UNITED STATES PATENT AND TRADEMARK OFFICE

APPLICATION NO.	FILING DATE	FIRST NAMED INVENTOR	ATTORNEY DOCKET NO.	CONFIRMATION NO.
10/759,531	01/20/2004	Kenneth M. Welborn	6292.211	7097

Office Action Summary	Application No. 10/759,531	Applicant(s) WELBORN ET AL.	
	Examiner Hemant M. Desai	Art Unit 3721

DETAILED ACTION

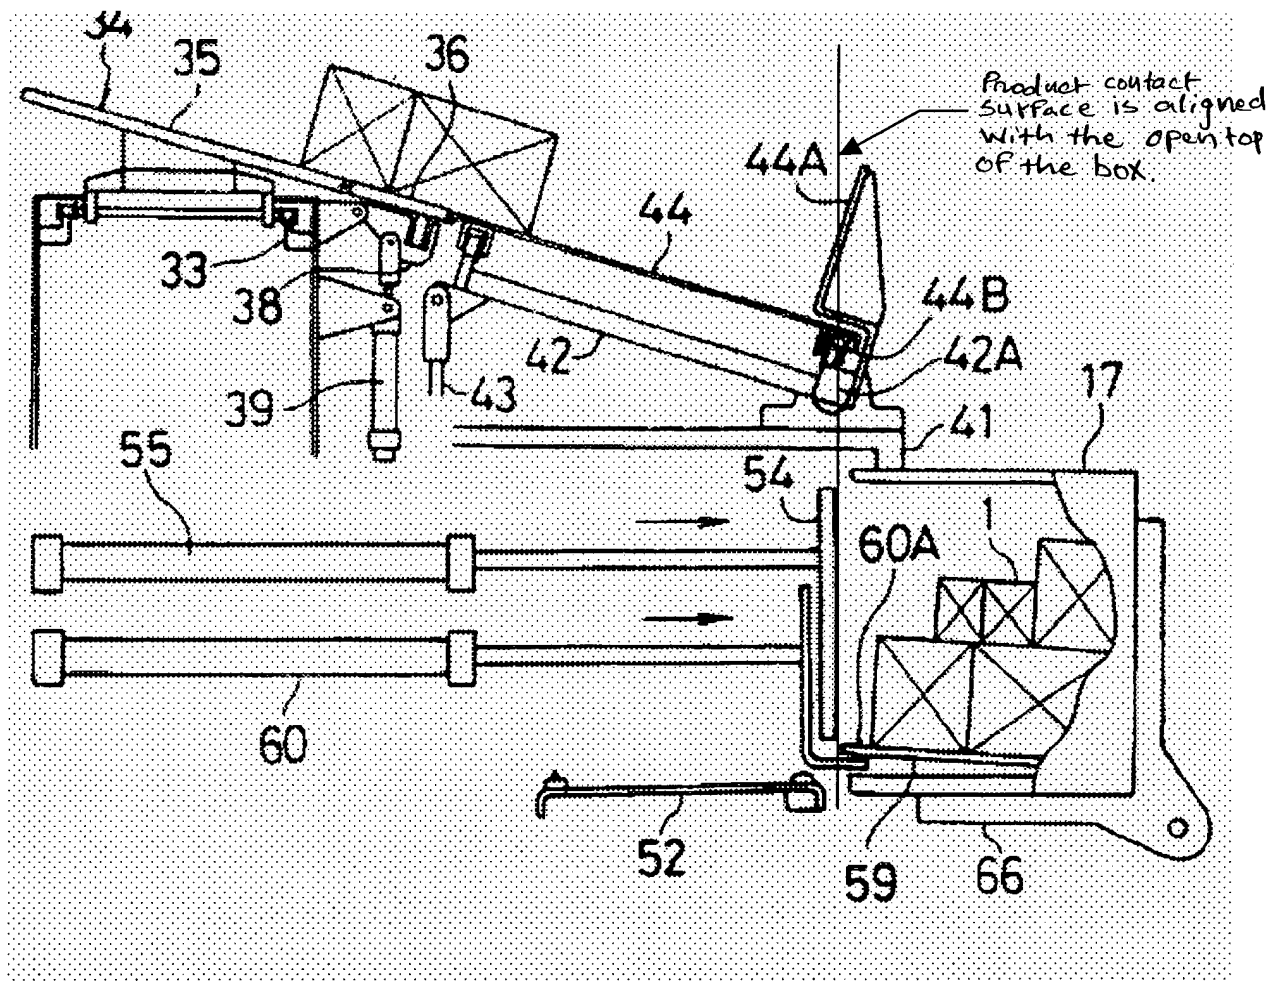
Tanka et al. disclose a packaging apparatus comprising a matrix former having a product contact surface (44, figs. 6A-10B) and an at least one movable sidewall (44, figs. 6A-10B), the matrix former being pivotable about an axis (compare figs. 7A-7B and 8A-8C) parallel to and spaced from the product contact surface between a first position (figs. 7A-7B) wherein the product contact surface (44) faces in a first direction and a

1. Applicant's arguments filed 11/23/2005 have been fully considered but they are not persuasive. In response to applicant's argument the above figure ^{Shows} ~~shows~~ that the product contact surface (44) is aligned with the open top of the box in the second angular orientation.
